RE: John Street Pond Feasibility Design Analysis Report
Engineer's Stamp Date: No Date
Hydrology File: L14D067

Based upon the information provided in your submittal received 10/13/2023, the Analysis Report **is not** approved. The following comments need to be addressed for approval of the above referenced project:

JOHN STREET POND FEASIBILITY DESIGN ANALYSIS REPORT

FIGURE 5:
JOHN STREET
GRADING OPTION 1
October 2023

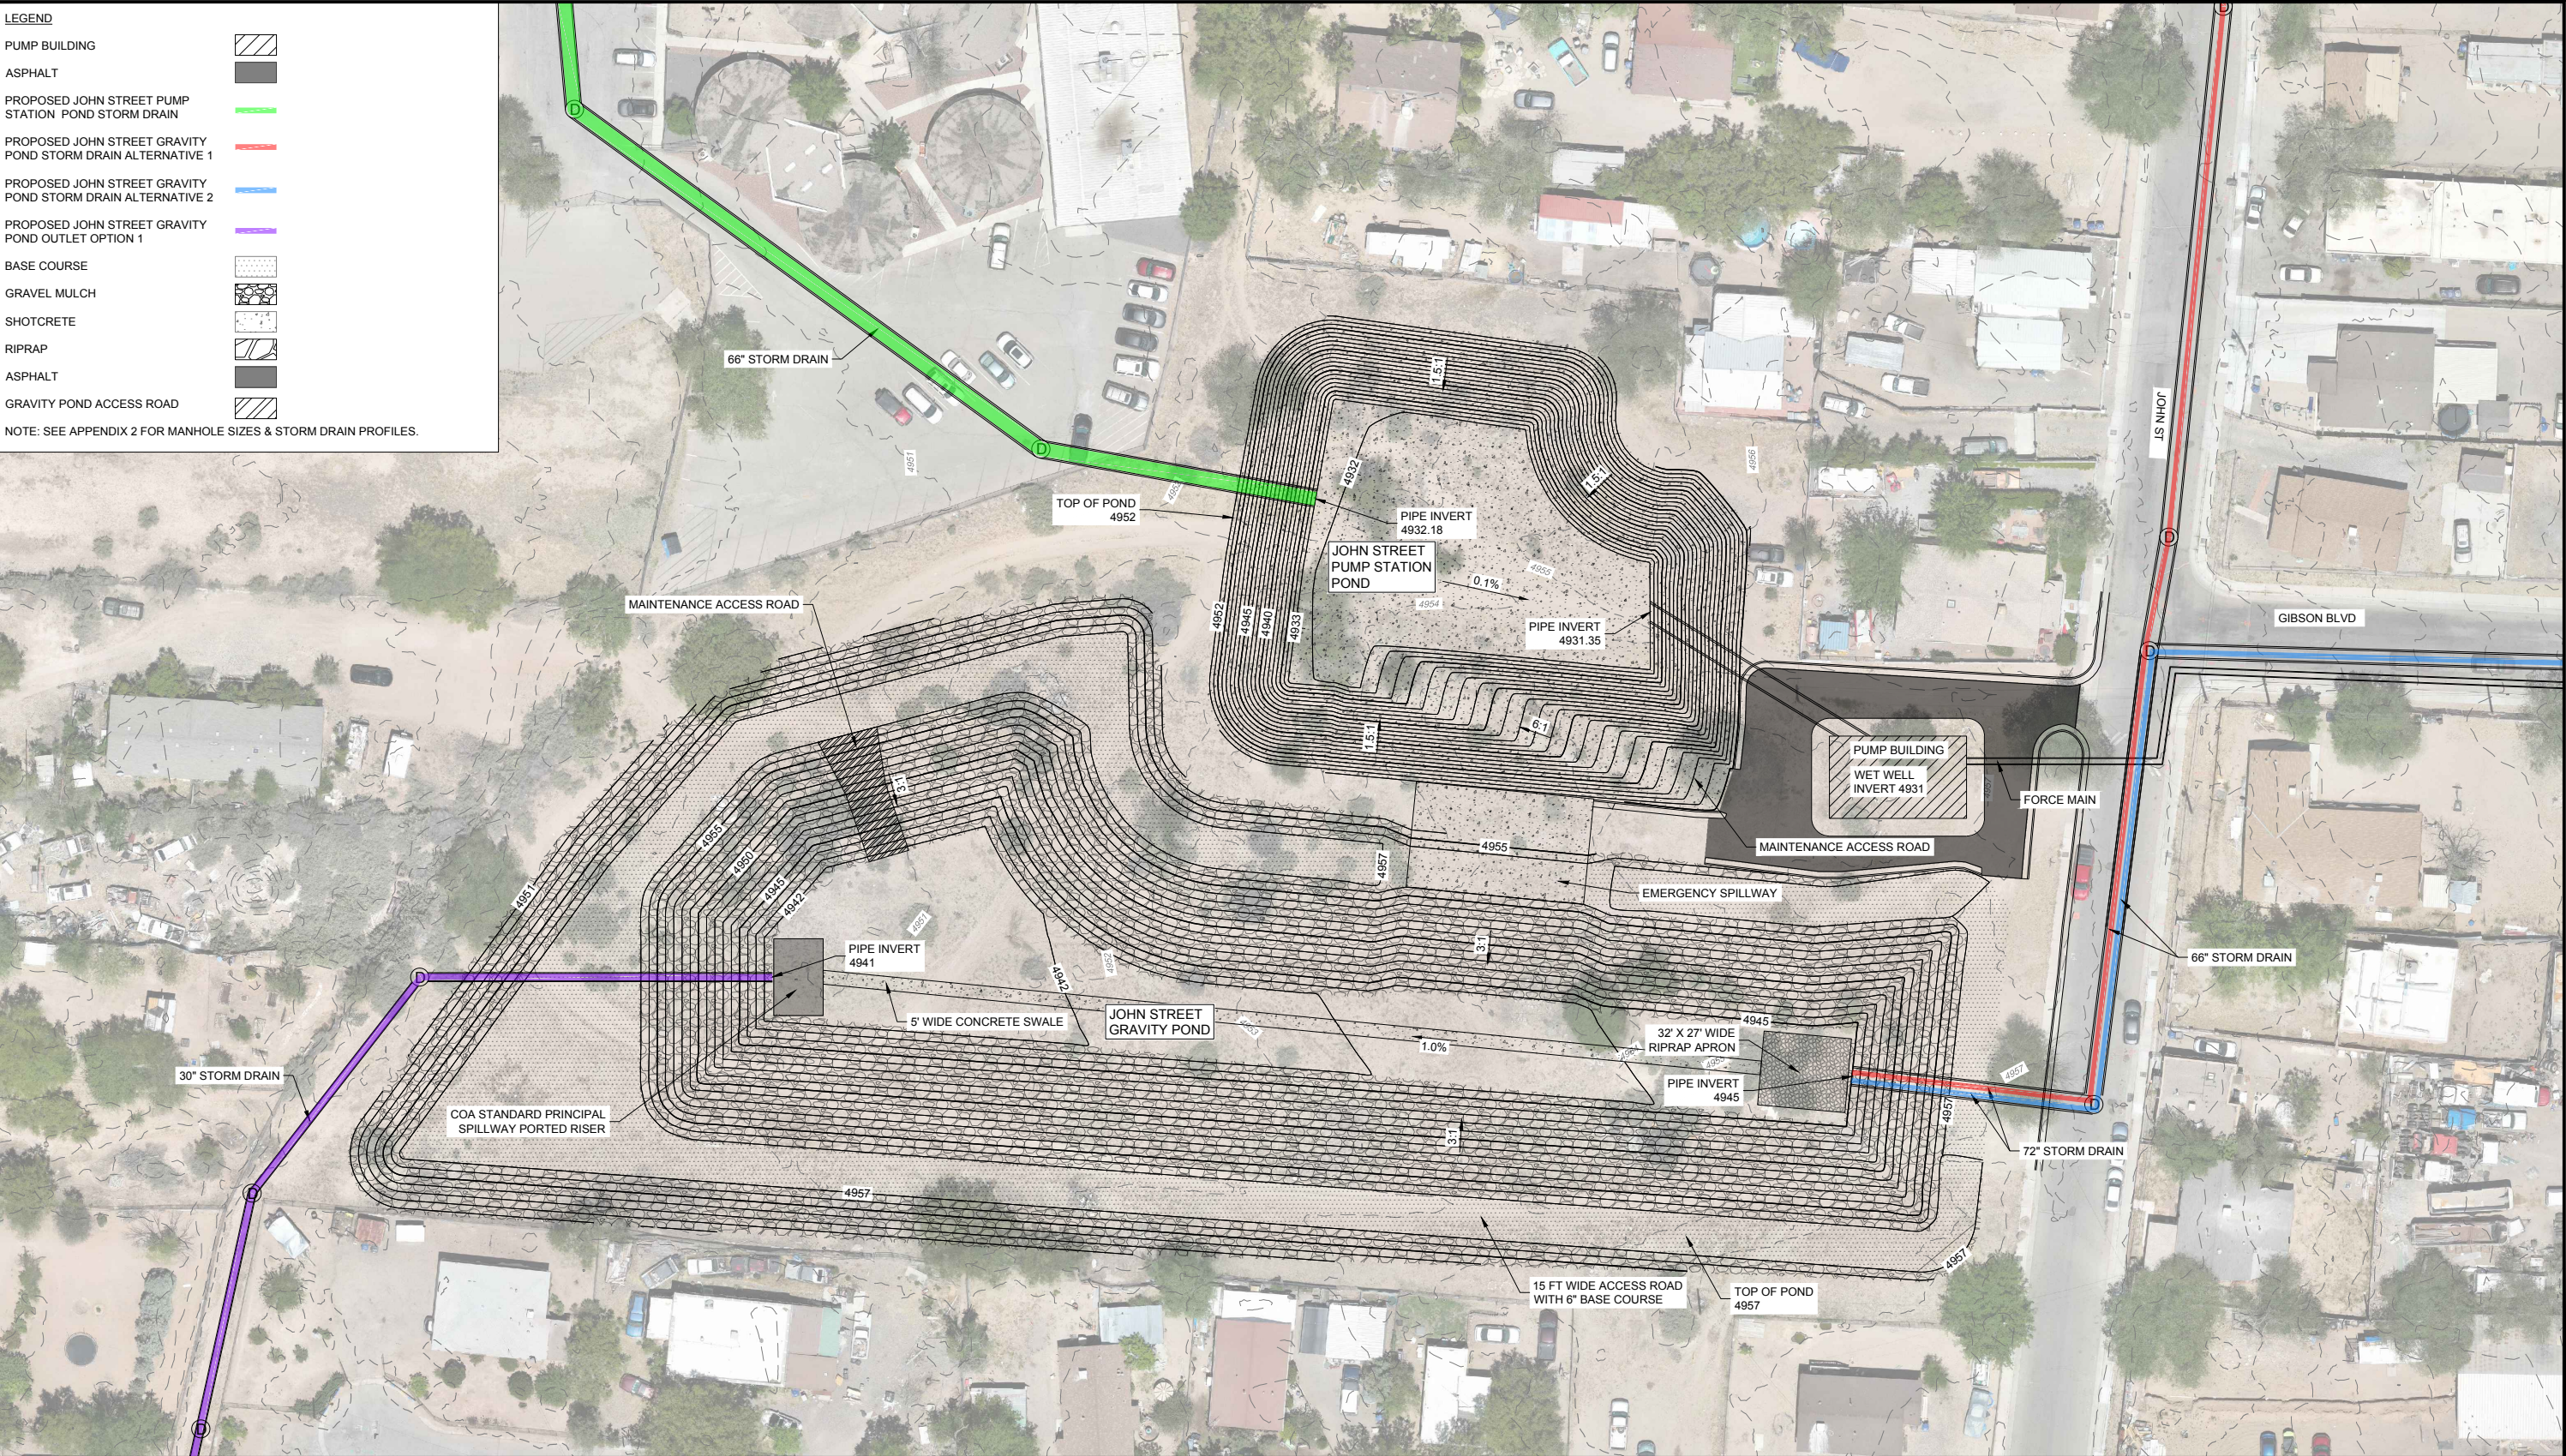
6. In 3.2.1 John Street Gravity Pond. For Option 1 & Option 2, the emergency spillway Q_{100} is shown in the tables but which design is being proposed for the COA Ported Riser Principle Spillway is being used in each option and the Q_{100} at the discharge is not mentioned either. Option 1 has a 30-inch RCP and Option 2 has a 24-inch RCP but that is all the information is given.
